APTB 06/07

SUBJECT: 6.0 L Power Stroke® Water Pump Identification

June 10, 2007

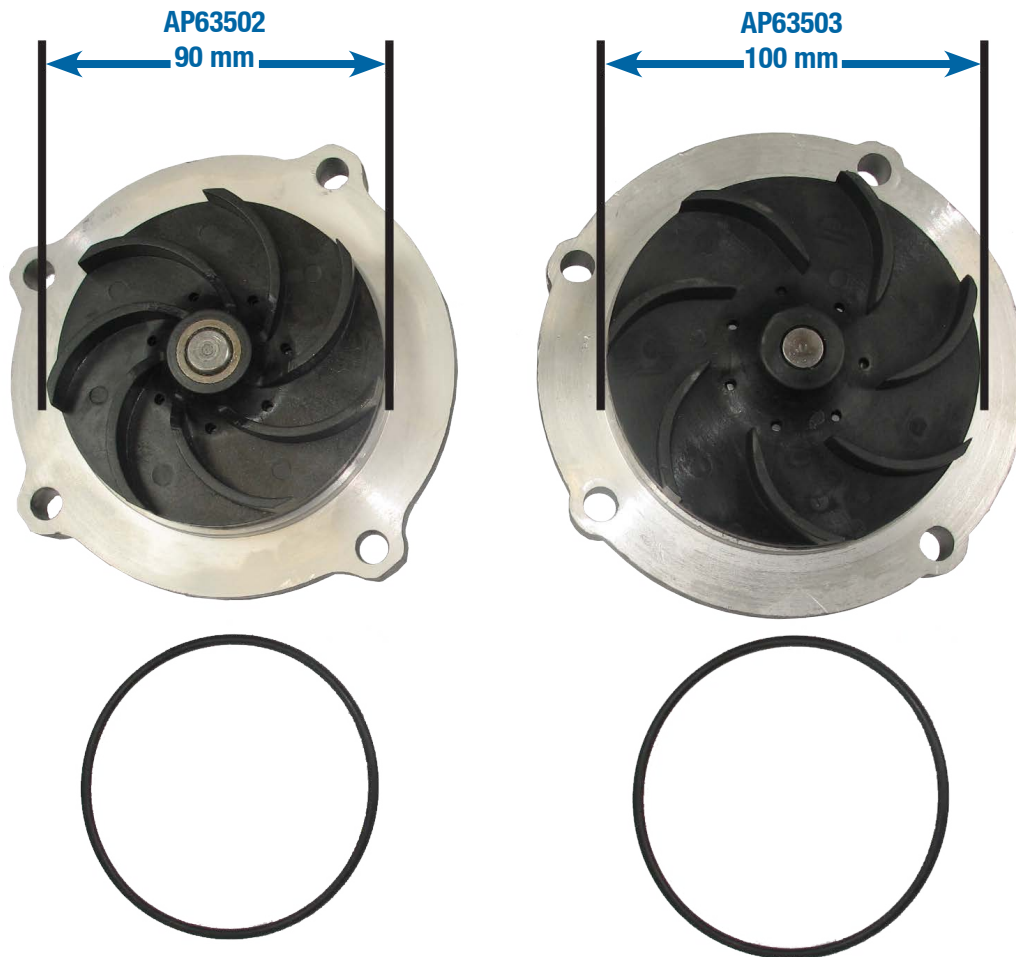
Ford® made a running change to 6.0 L Power Stroke (all models except F-650 / F-750) water pumps and engine front covers. This change increases coolant flow in order to offset higher engine heat rejection. As shown in the photo below, the new pump **AP63503** can be identified by a larger impeller diameter than the original pump **AP63502**. The front cover was updated as well to proportionally increase the water pump sealing area.

Caution: Both pumps have the same bolt pattern but different sealing areas. As a result, the original pump **AP63502** could be inadvertently installed in place of a newer pump **AP63503**, likely resulting in coolant leakage and engine overheating. Because of different sealing areas, the new pump cannot be installed in place of the original pump.
